County of Fairfax, Virginia

STAFF REPORT

SPECIAL PERMIT SP 2016-BR-002

APPLICANT: Expectation Church, Inc.
OWNER: Expectation Church, Inc.
STREET ADDRESS: 11924 Braddock Road, Fairfax 22030
TAX MAP REFERENCE: 67-1 ((1)) 33
LOT SIZE: 31.567 acres
ZONING DISTRICT: R-C
ZONING ORDINANCE PROVISION: 3-C03
SPECIAL PERMIT PROPOSAL: To permit a place of worship.

SHEET 1 of 16

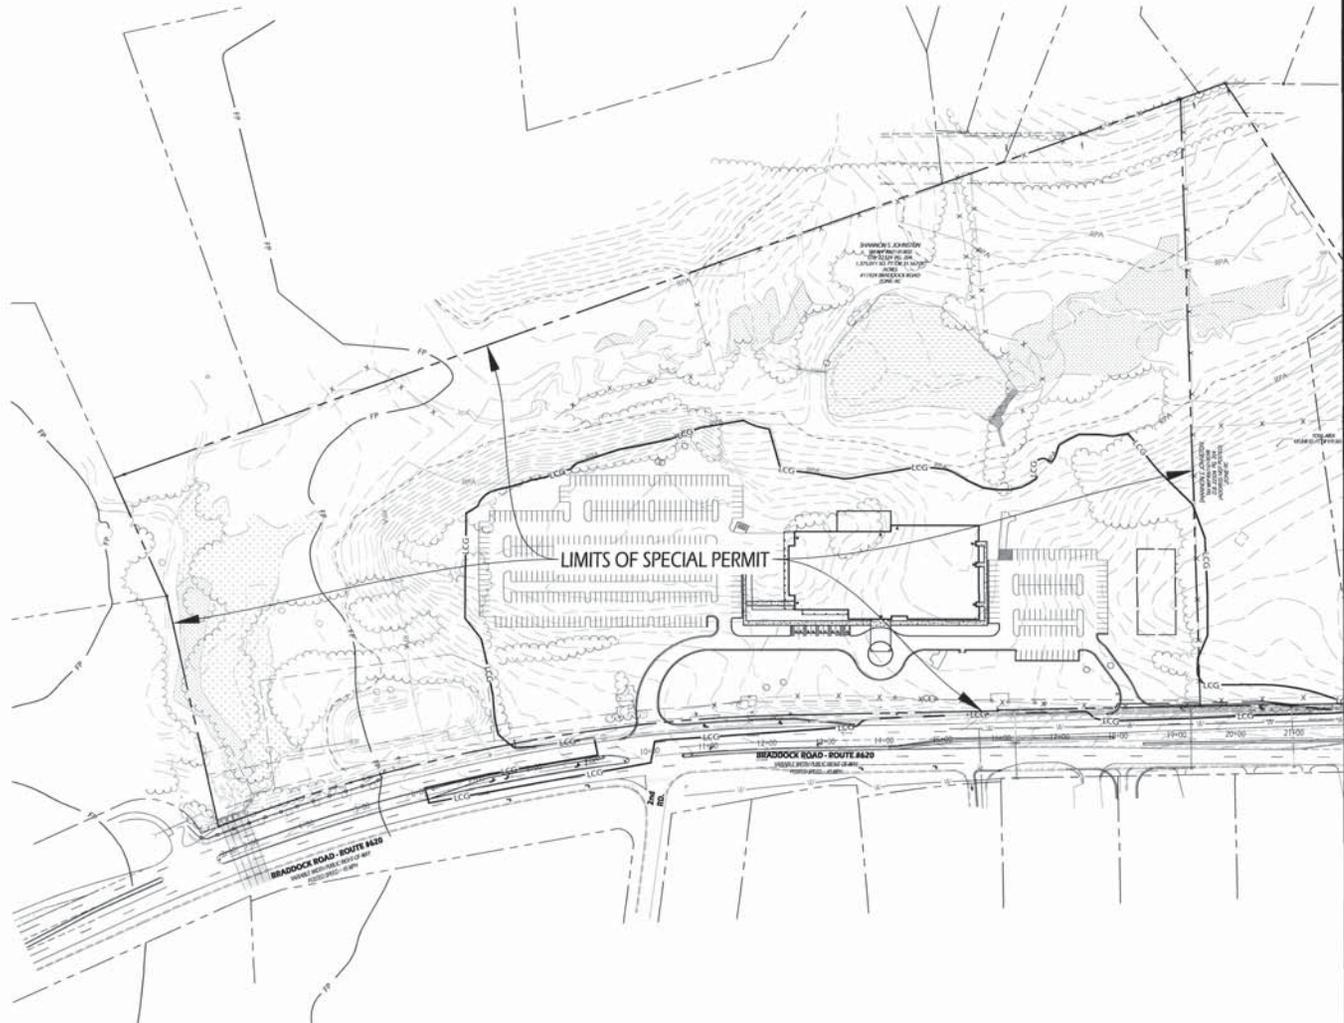
There is Resource Protection Area (RPA) located on the project property. Note 25 on Sheet 1 acknowledges this fact, and states that the County's mapped RPA boundaries (both 1993 & 2003 boundaries) are shown on the plans. The note also identifies a "field verified" RPA boundary that is shown on the plans, and is different from the County's mapped boundaries. No record can be found for an approved RPA redelineation study for the site. So, the "field verified" RPA boundary (designated as RPA-TNT) must be removed from the SP plans, since it is not a valid boundary at this time. Note, however, that the approval of a separate site-specific RPA redelineation study is required for this project (per PFM 6-1701.3) during the final design/site plan stage; and once the site-specific RPA boundary is approved, currently proposed facility locations and the limits of land disturbance will need to be adjusted if impacted by any final RPA boundaries expanding beyond the County-mapped boundaries.
